14 October 2022

Assessment number 2320

Ashburton Infrastructure Project – Responses to EPA Comments on Marine aspects and revised Marine Management Plans

Figure 7 1: Existing and Proposed Construction Ecological Protection Areas for the Proposal

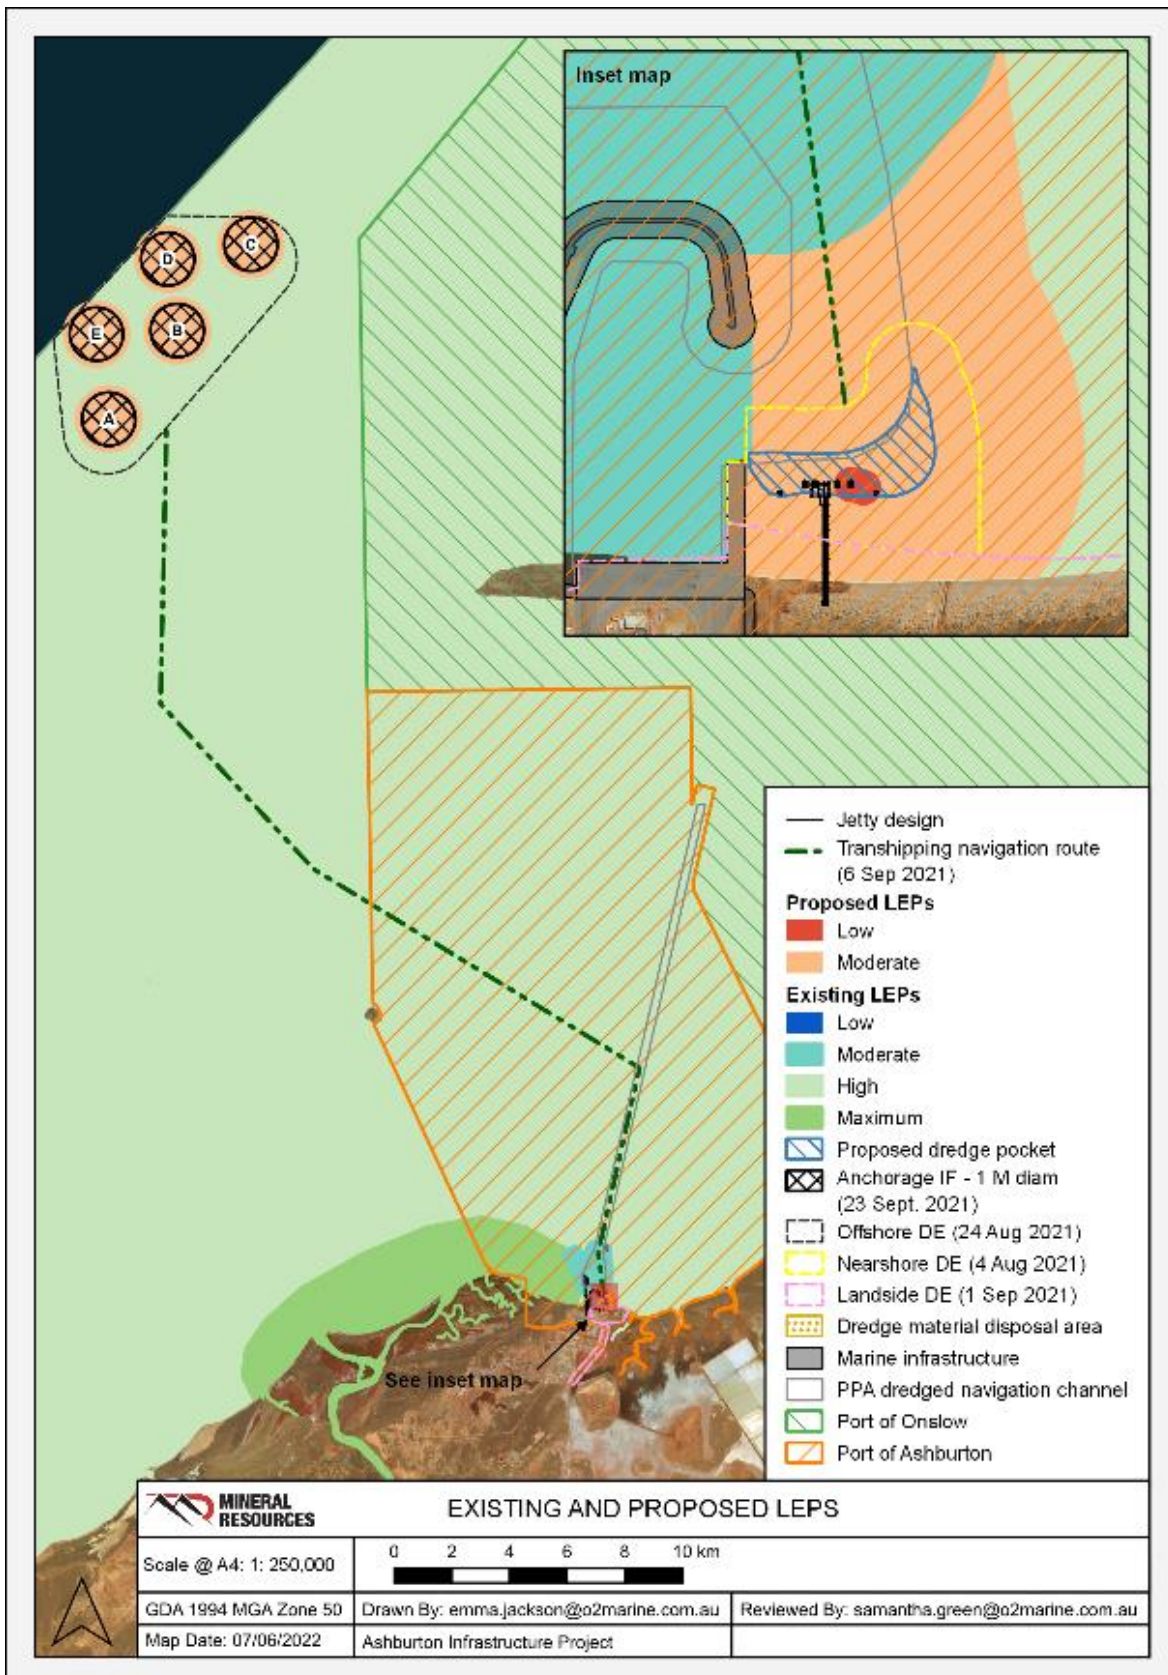
<p>3.Cumulative assessment of multiple wastewater discharge plumes to the nearshore marine environment The proponent should include a map with all the existing and planned wastewater discharge locations and the respective levels of ecological protection. Achieving the approved levels of ecological protection for each project will effectively mean that cumulative impacts on marine environmental quality are being adequately managed. The Environmental Quality Plan (EQP) required for assessing and managing impacts on environmental quality also addresses cumulative impact to some degree. Noted that additional modelling is not possible and required if levels of ecological protection are separated from each other.</p>	<p>Noted – The temporary desalination plant associated with the Wheatstone development has recently been decommissioned so this not considered in any cumulative impact. The inclusion of the proposed desalination discharge would essentially maintain the previous impacts, with this not expected to result in an increased cumulative impact. This assessment relies on maintaining MEQ objectives for each of the identified environmental values. The Marine OEMMP Identified Waste discharges from Wheatstone LNG and Onslow Salt waste brine outfall and specifies the nominated LEP's within the project area.</p>	<p>The proponent should still provide a map with the existing discharge locations (e.g., Wheatstone LNG facility and Onslow Salt waste brine outfall) and the respective levels of ecological protection zones.</p>	<p>Figure 7 1: Existing and Proposed Construction Ecological Protection Areas for the Proposal (see Section 7.6.2.3, pg. 104), displays the existing Low EPs, and the proposed combined Low EPs (see Attachment 2).</p>
